RE: 14300 Lora Drive

I reviewed the drawings and evaluated the site context. I have previously reviewed one other house on this block. My comments and recommendations are as follows:

PROPOSED FRONT ELEVATION

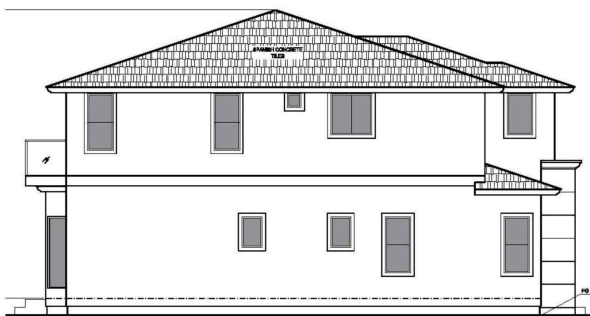
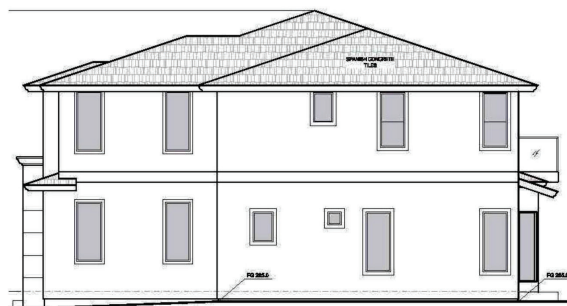
1. As noted above, the design does not have a clearly identified architectural style, and the front and rear elevations have features that are not repeated on the side elevations which would not be consistent with Residential Design Guideline 3.2.2.

2. The proposed design has an irregular profile, presumably in an attempt to break down the building mass and allow some first floor roofs which are often incorporated on homes designed in the Mediterranean Style. The resultant massing is not well organized, and adds little to the overall design. This would appear to not be consistent with Residential Design Guideline 3.3.1.

3. The side elevations are unbroken two-story walls with no additional detail or articulation which would not be consistent with Residential Design Guideline 3.3.3.

4. No clear information is provided on the proposed windows, but they appear on the plans and elevations to include relatively narrow widow sashes and surrounding trim which would not be consistent with Residential Design Guidelines 3.7.3 and 3.7.4.

5. The proposed bay window on the rear elevation is quite awkward, and seems inconsistent with the rest of the design.
6. The second floor balcony on the rear of the house is not well integrated into the design, and would not be consistent with Residential Design Guideline 3.10.2.

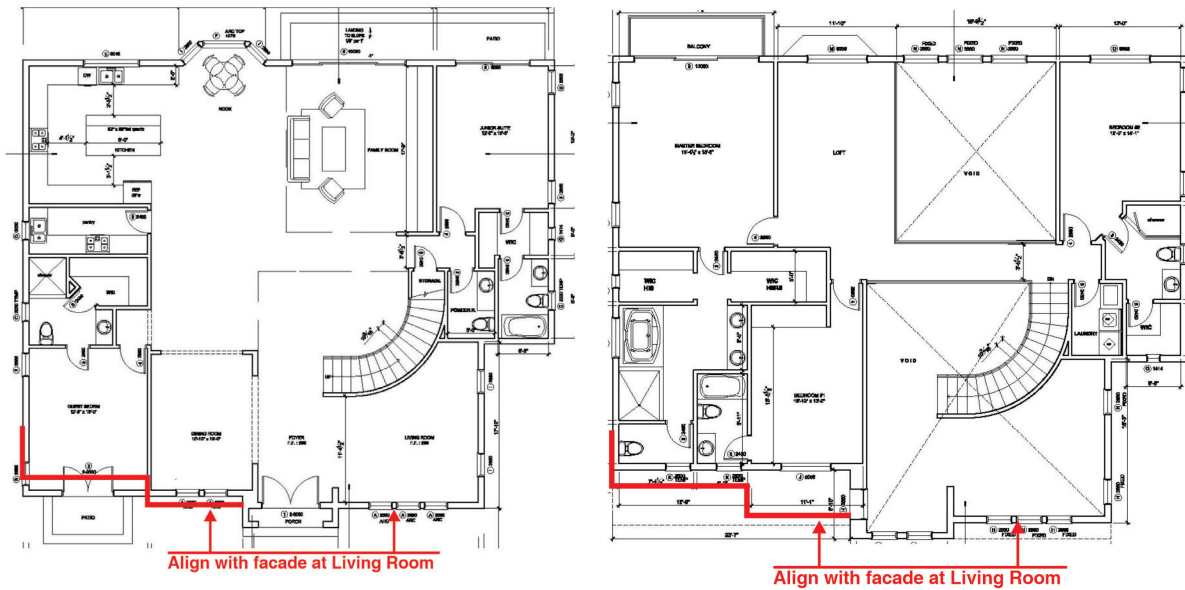
1. Simplify the front facade form to allow a building envelope more typical of the formal Mediterranean Style.

2. Select windows with substantial sash and wood or cast stone trim widths to match traditional windows appropriate to the style - See photo examples below.
3. Provide cast stone projecting trim below second floor windows on all four sides of the house - see example on the left side photo example below.

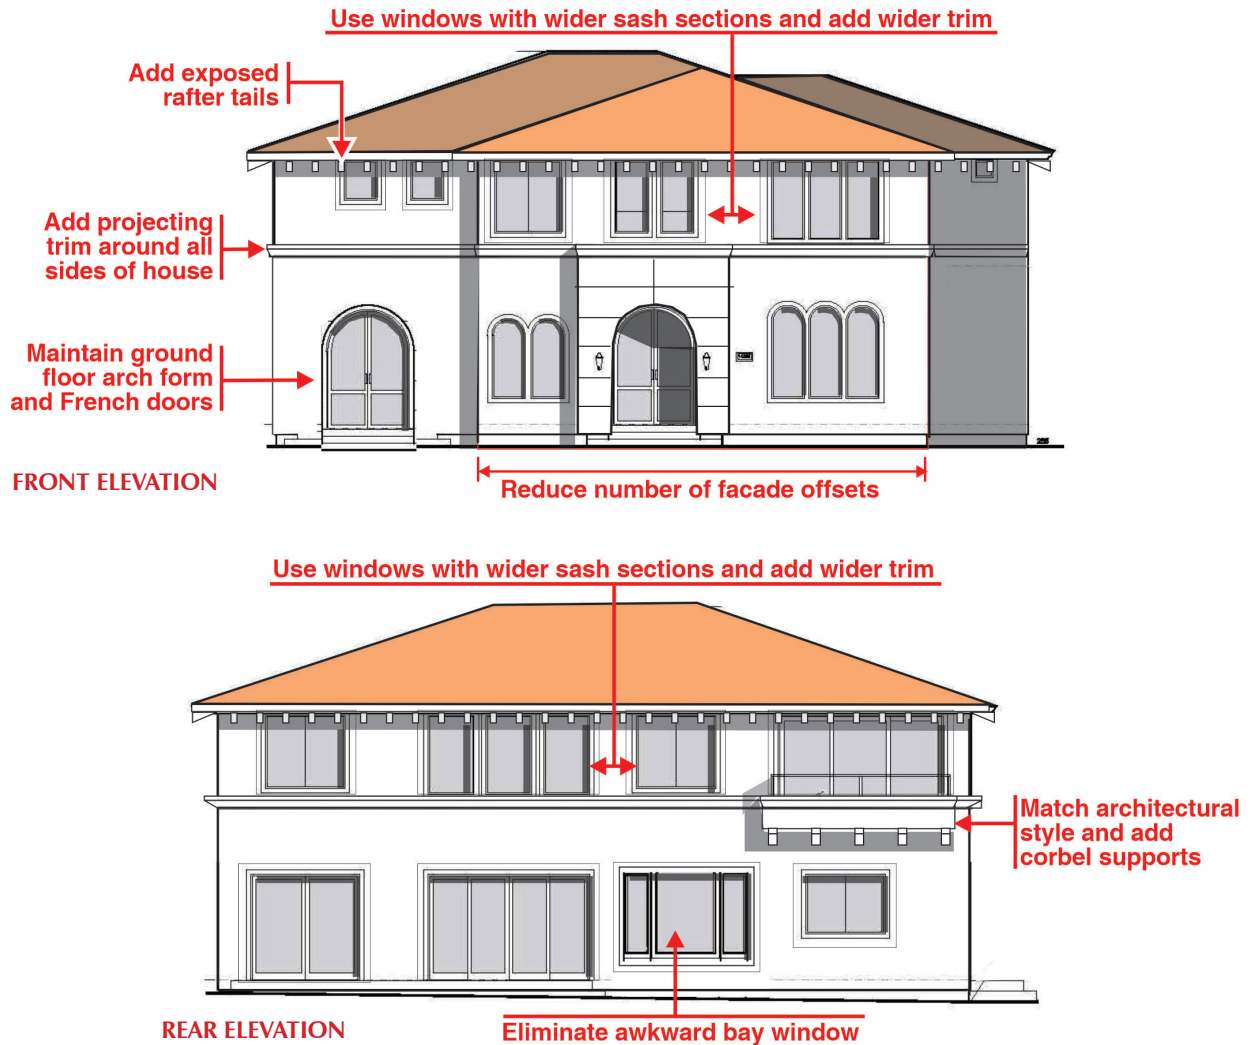
4. Use arched window forms on all front elevation first floor windows and doors.
5. Add exposed rafter tails at the roof eaves.
6. Eliminate the rear elevation bay window.
7. Revise the design and supports for the rear second floor balcony to better relate it to the overall house design.
8. Revise side elevation to match front and rear elevations.
9. Add additional architectural detail appropriate to the architectural style.
10. Add buffer landscaping in side and rear setbacks.
